SUBJECT: TECHNICAL SERVICE BULLETIN LISTING

1986 TECHNICAL SERVICE BULLETINS

Homelite Division of Textron Inc.

SUBJECT: THREE-SHOE UNLINED CLUTCH A-98129

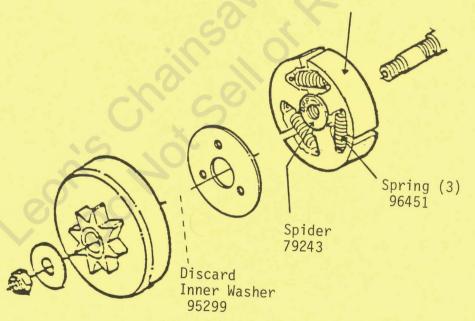
A three-shoe unlined clutch assembly A-98129 has replaced the S-Clutch on the Model 240 and the three-shoe lined clutch on the Model 245. Refer to the diagram below when ordering parts for this new clutch assembly.

For Model 240 - Discard clutch cover 69915-1, screws (2) 97605, and inner washer (1) 95299.

For Model 245 - Discard clutch cover 96919-1, screws (3) 97605, and inner washer (1) 95299.

Install clutch assembly A-98129 with the "OFF \rightarrow " facing out. Torque clutch assembly to 250 - 300 in.1bs. (28,2 - 33.9 Nm).

SUBJECT: LOCATING SCREW FOR DRIVESHAFT HOUSING

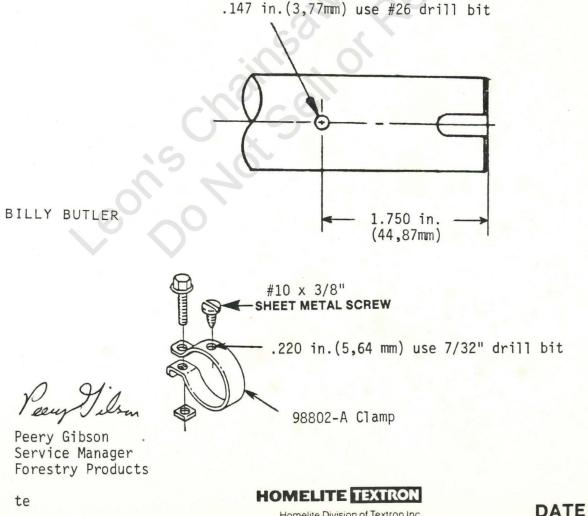
The models ST-155 and ST-175 trimmers built starting with Lot #I064 use a #10 x 3/8" sheet metal screw and clamp 98802-A to secure the engine housing to the driveshaft housing. The driveshaft housing also has a .147" diameter hole to accept the new screw.

Trimmers built prior to Lot #I064 can be modified by drilling a .220" (7/32" drill bit) hole in the existing clamp (or using clamp 98802-A), drilling *a .147" (#26 drill bit) diameter hole in the driveshaft housing as shown in the diagram below, and using a #10 x 3/8" sheet metal screw. The diagram below may also be used as a template.

When drilling hole in driveshaft housing do not pierce inner star liner or flexible driveshaft.

SUBJECT: DEFLECTOR IN MUFFLER COVER NOT DRILLED

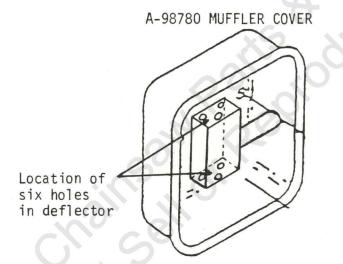
Any of the above subject units exhibiting symptoms* of low power, low no-load RPM, and/or hard starting should be checked to see if the deflector welded inside the muffler cover (Part #A-98780) has the correct number of holes drilled in it.

There should be a total of six (three in the top and three in the bottom) 5/32" diameter holes drilled in the deflector (see illustration below).

SUBJECT: MISSING PARTS FROM PARTS LIST

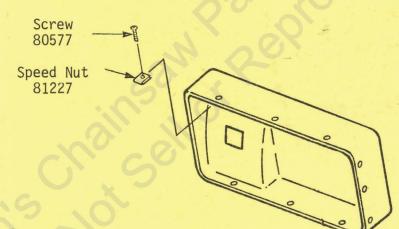
The DC Battery Charging lead for the HG3500 was not included in the parts list. The part number for the DC Lead is A-49380. The speed nut and screw for the panel cover are also missing from the parts list. Please correct your parts list accordingly.
